**Pacific Gas and
Electric Company**

Electric T&D Bulletin

Title: Underground Residential & Commercial Construction

This revision to bulletin 2007-09 is being issued to provide additional clarity to the use and intent of the bulletin. Changes have been made to Table 1, the Figures 2A and 2B, and the Financial and Tariff section. A grandfather clause has been added for applicant design jobs that have gone through multiple reviews prior to issuance of the bulletin. The bulletin was originally intended for use with new business construction however it is not limited to new business.

Figure 2a – Design to accommodate future expansion

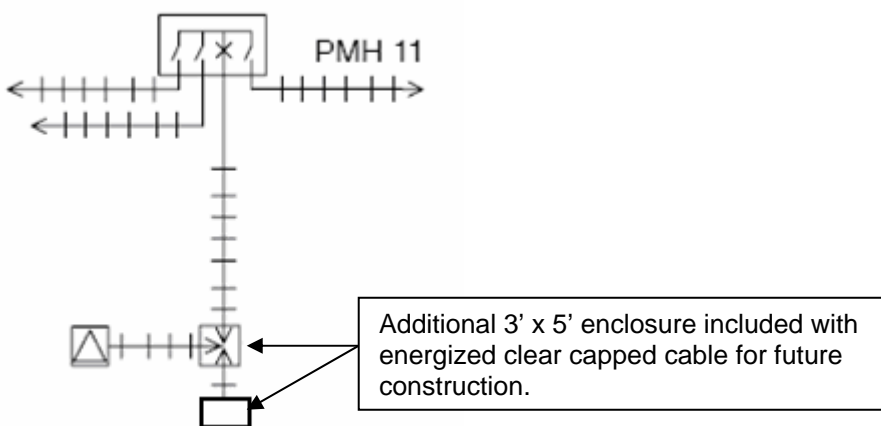
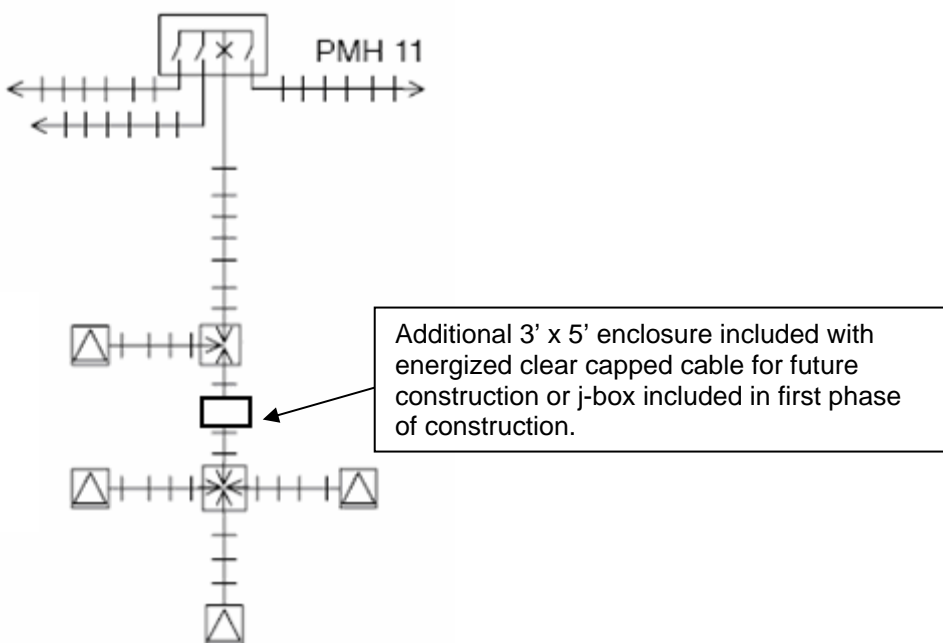
Figure 2a/2b illustrates a scenario where a 200 amp tap is being built in phased construction. The addition of a 3' x 5' enclosure and cable into the enclosure from the junction allows for the last phase of construction to be built without impact to the initial phased construction. By energizing the cable prior to installation the cable will not be considered idle and can remain in the ground for any length of time. When the next phase of construction is built, the new cable(s) can be pulled into the additional pull box and the source cables can be de-energized for splicing by pulling the load break elbows at the J-box or transformer without any customers being de-energized.

As shown in Figure 2a and 2b below, an additional 3' x 5' enclosure is included as a pull box to provide for future cable pulls into an enclosure that doesn't require de-energizing, preventing initial phased customers from experiencing an unnecessary planned outage.

Note: Clear Capping of cable is to be accomplished by utilizing a dead break elbow along with an insulated standoff bushing, and mounted and secured on racking pins installed to support future splice(s). Use of a dead break elbow will enable the cable tails to be tested de-energized and grounded for future splicing.
